# PLANNING COMMISSION AGENDA

**Item No**. 1.
**Title:** Final Site Plan Amendment - Fineline Steel Fabrication - 975 West 50 South - Industrial Development - 975 Fifty LLC - Administrative Decision
**Initiated By:** Tyler Oliver, applicant
**Staff Representative:** Sydney DeWees, Assistant Planner, Mike Eggett, Community Development Director

Consider Final Site Plan Amendment for Fineline Steel Fabrication, located at approximately 975 West 50 South, amending the site plan use, building footprint, and cross-access travel lane connection to the neighboring Steelworks site.

STAFF REPORT
AGENDA ITEM: 1
Fineline Steel Fabrication– Site Plan Amendment Planned Development

## AS BUILT REVISIONS 6/30/26

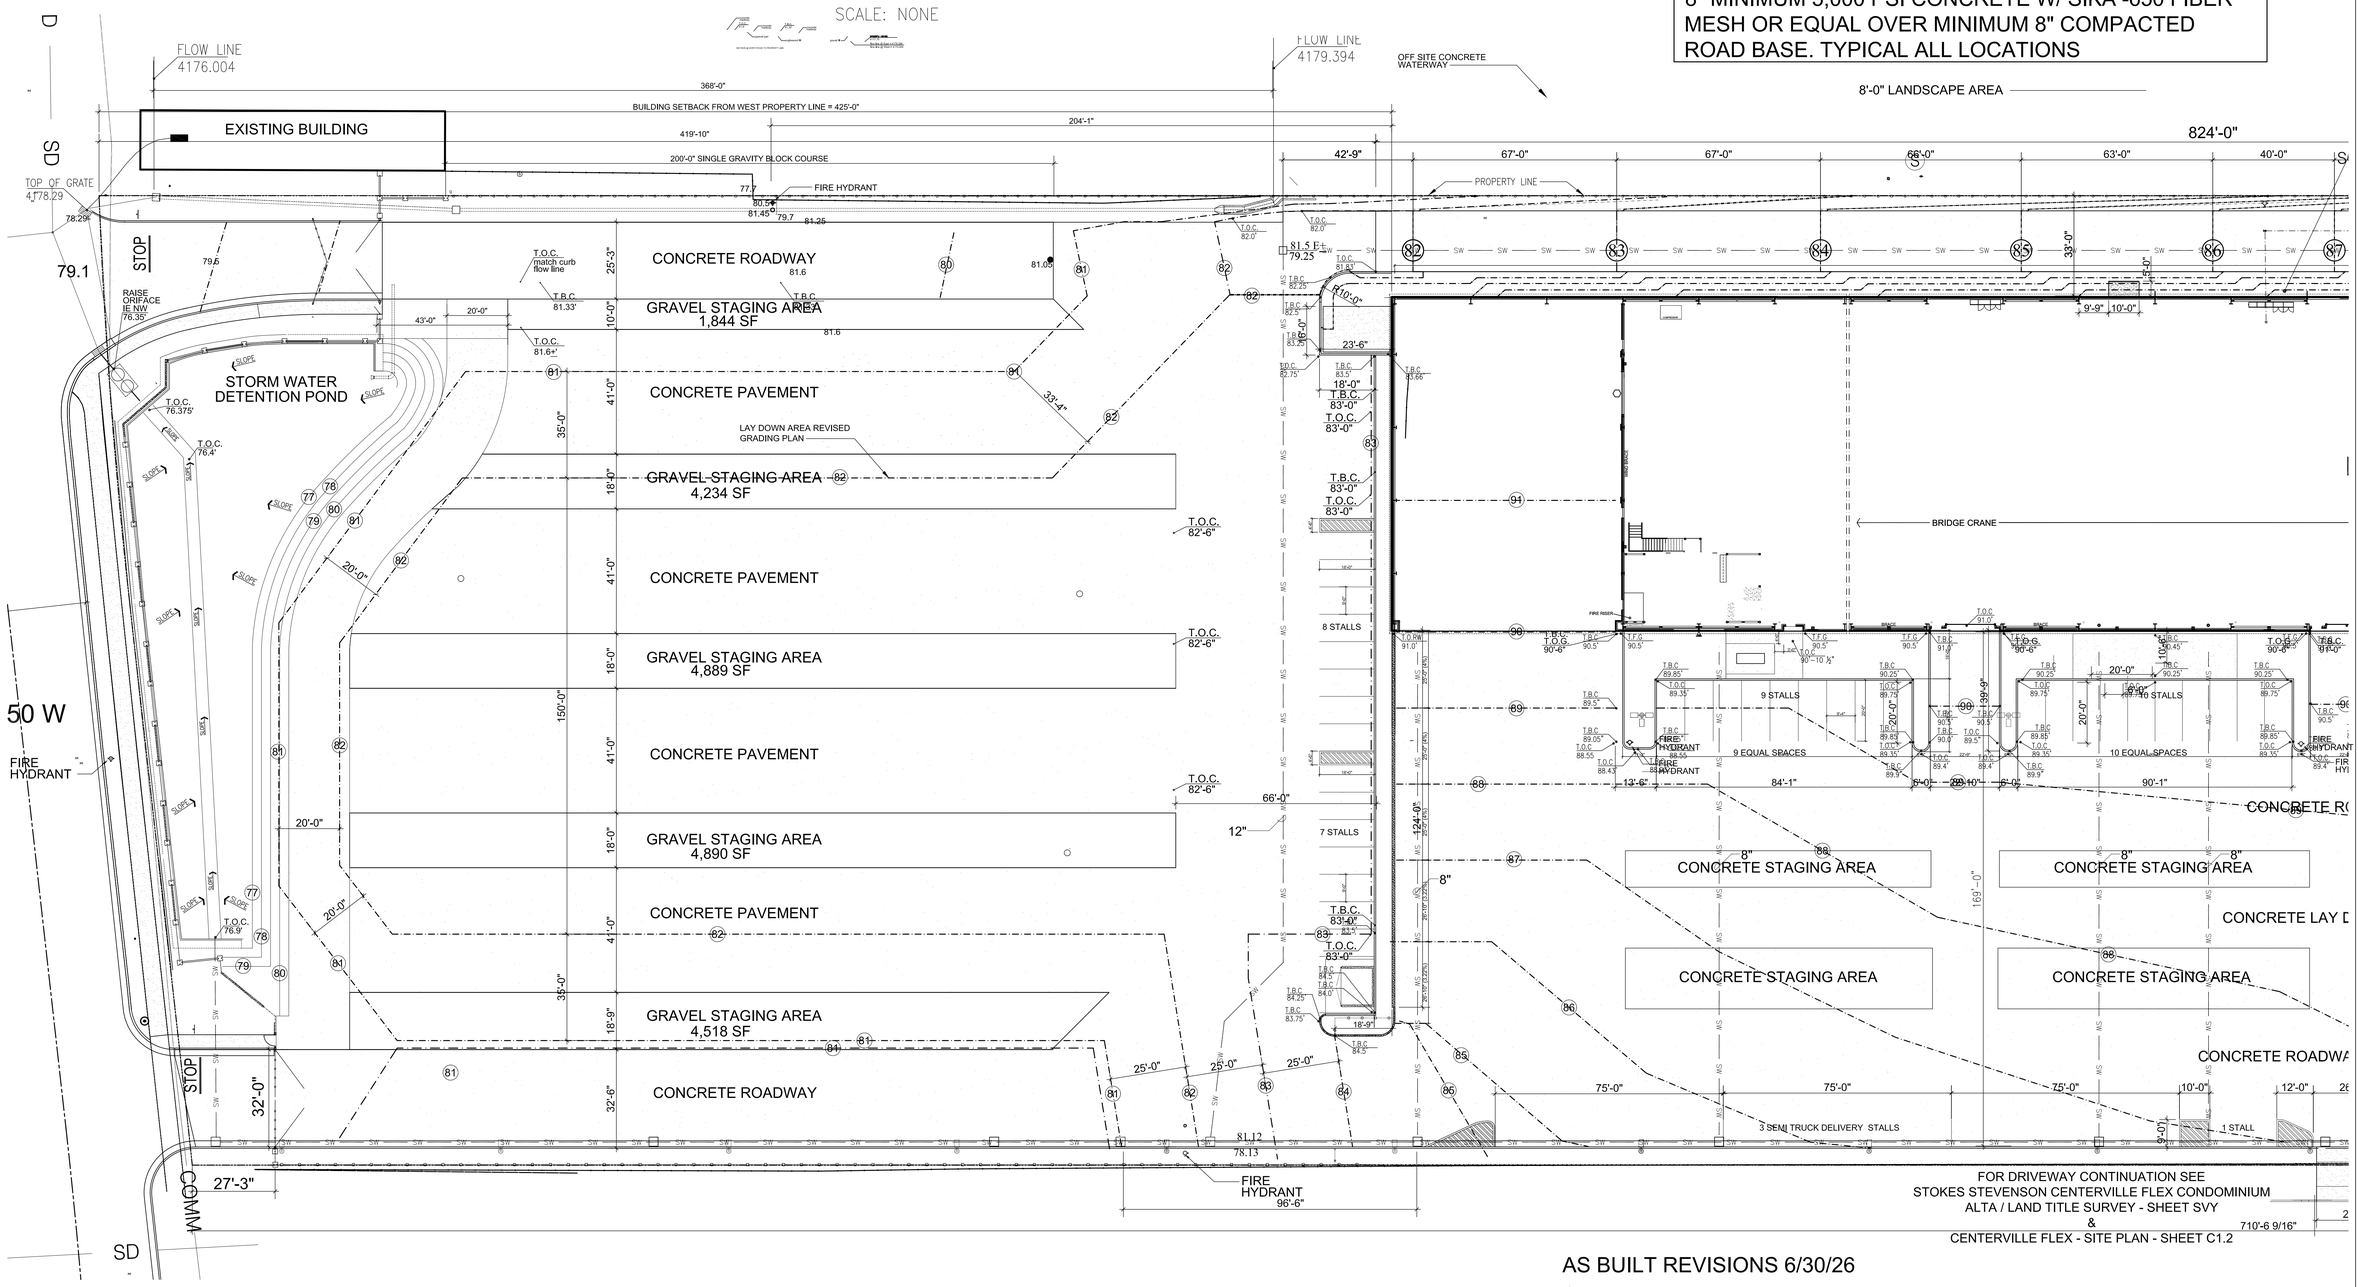
1c. THE STORM WATER DETENTION POND HAS BEEN REVISED TO ALIGN WITH THE REVISED ELEVATIONS OF THE FLOW LINES OF THE CITY STORM WATER SYSTEM

EAST SITE GRADING & UTILITY UPDATES

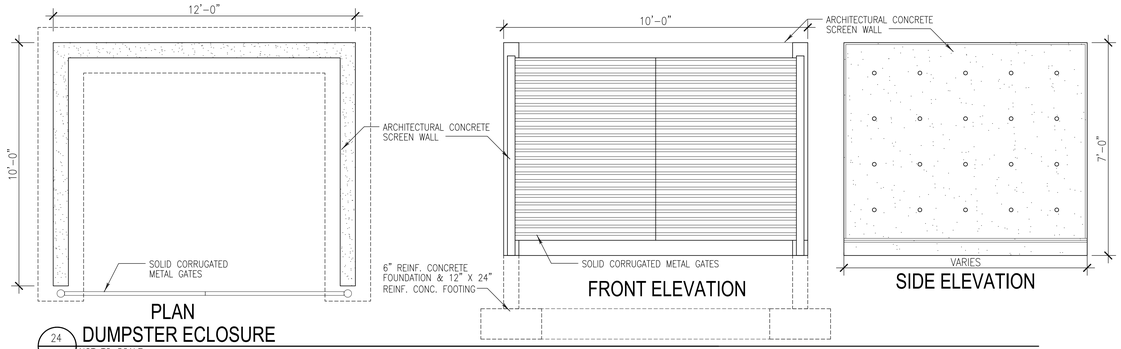
ONE ADDITIONAL ACCESSIBLE PARKING STALL ADDED TO PROVIDE 5 TOTAL

THE STORM WATER DETENTION POND HAS BEEN REVISED TO ALIGN WITH THE REVISED ELEVATIONS OF THE FLOW LINES OF THE CITY STORM WATER SYSTEM
